Dam Safety Inspection Report

Name: **Nichols Pond**
State ID: **252.01** NID ID: **VT00184**
Hazard Class: **High Hazard Potential**

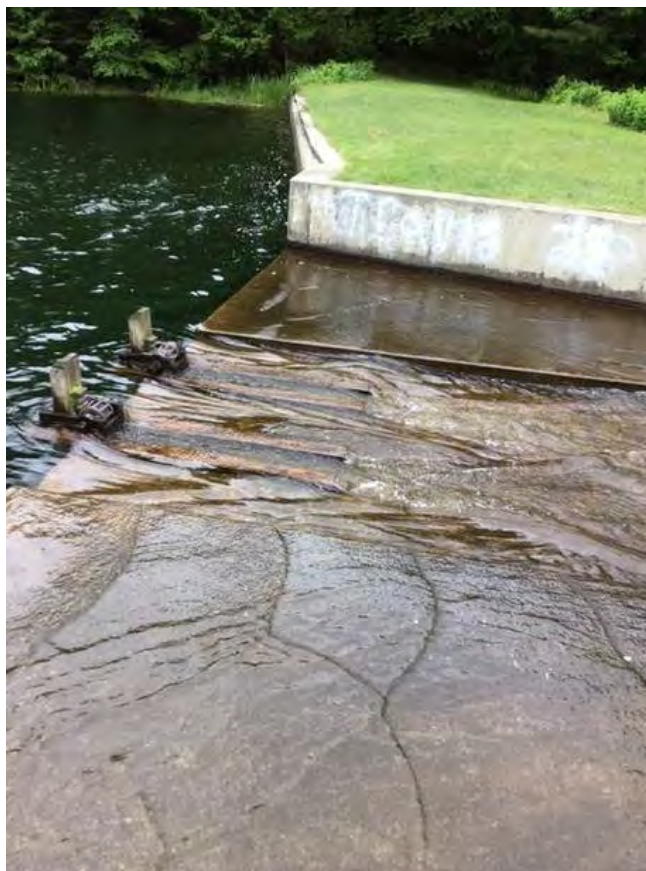
Principal Spillway
Spillway type: Weir Primary material: Concrete Weir: Broad-Crested
Spillway location: Center of dam
Water level measured against principal spillway crest: 7" above Erosion control structures: End Sill, Rock-Lined Channel
Spillway components: <input type="checkbox"/> Anti-vortex plate <input type="checkbox"/> Filter Diaphragm <input type="checkbox"/> Training Walls <input type="checkbox"/> Flashboard <input type="checkbox"/> Trashrack <input checked="" type="checkbox"/> Other: Safety rack
Additional comments: Consider replacing the safety rack at the downstream end of the spillway with one with a larger grid opening size to reduce potential for debris getting caught on it.
